Sheo Sanderson Memorial Ward attached to the Civil Hospital at Chichuacaper.

European Planter's Ward AT Chikmagalore

Report to accompany the approximate Estimate of the probable cost of constructing a European planters' ward at Chikmagalur.

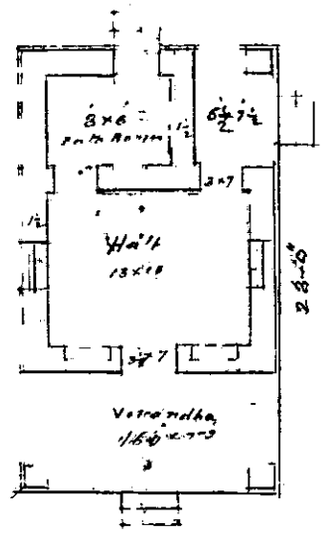
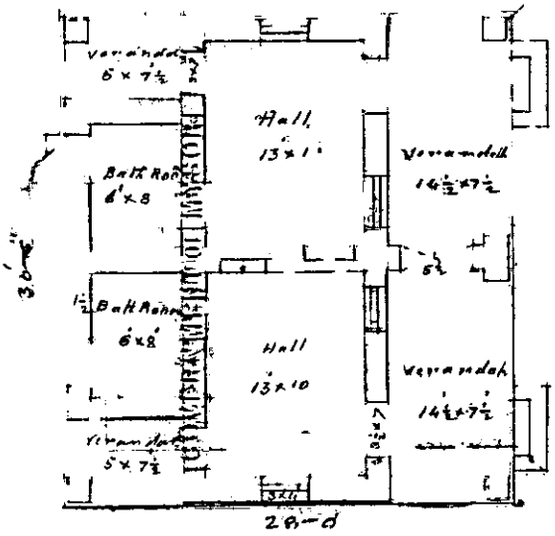
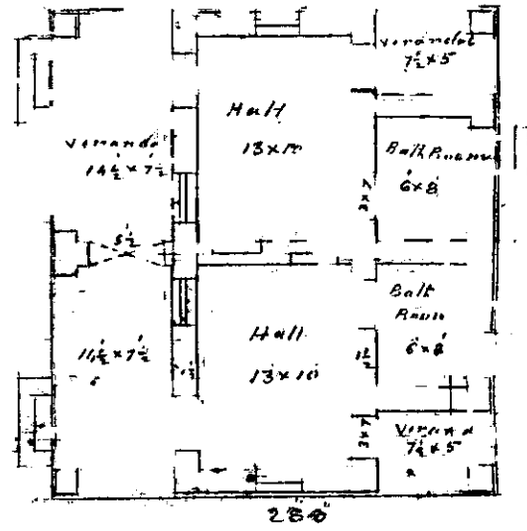
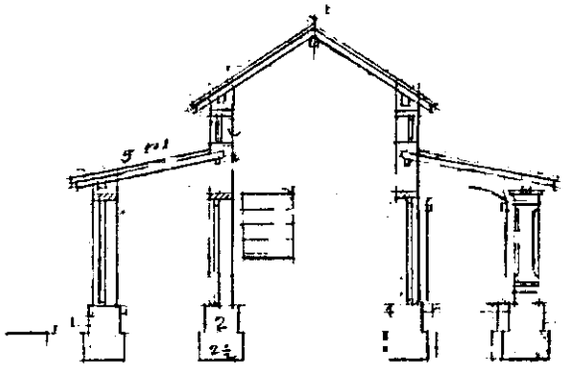
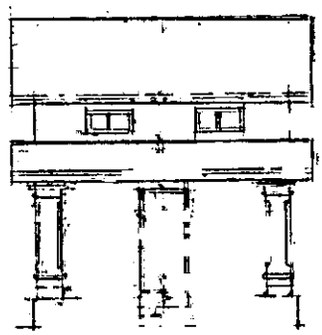
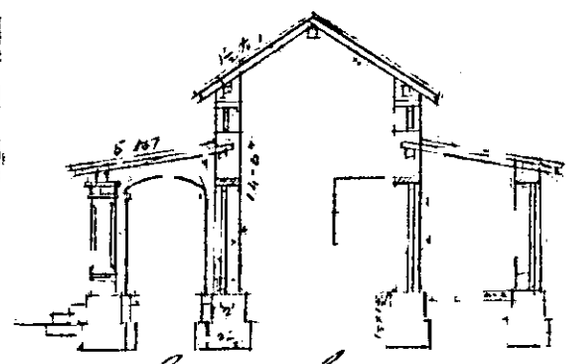
6. The accompanying plan is so designed to meet the requirements as formulated by the Senior Surgeon in his No 596 of 16th May 1895, as far as the same was possible with a due regard to construction demands and symmetrical disposition of the blocks. The plan is in pencil and the estimate is for plinth area at the average rate of 2 Rupees per square foot. Till the plan is passed and decided upon, and for a decision, the estimate accompanying is sufficiently approximate, there is little need for completing the project in detail.

7. Accommodation is provided in the plan accompanying for five beds, 4 in the side blocks and 1 in the centre block. The last may be generally used by the nurse or other attendants, and in an emergency it may be converted into a ward. The bath rooms are small. So is also the money limit.

8 – The proposal to have 2 Wards, one with 2 beds and the other with 3, had to be slightly modified in the interests of symmetry. In course of time as funds permit, the proposed arrange= =ment of the blocks admits of the con= =struction of covered passage from the centre to the side blocks.

2. It will be observed that the present plan contains no bow windows and which I understood from the Senior Surgeon to be a sine qua non, however should the present plan be approved of by Government and the Senior Surgeon I will request

Submit to Council the Plan now approved of the Estimate & the Grant in aid
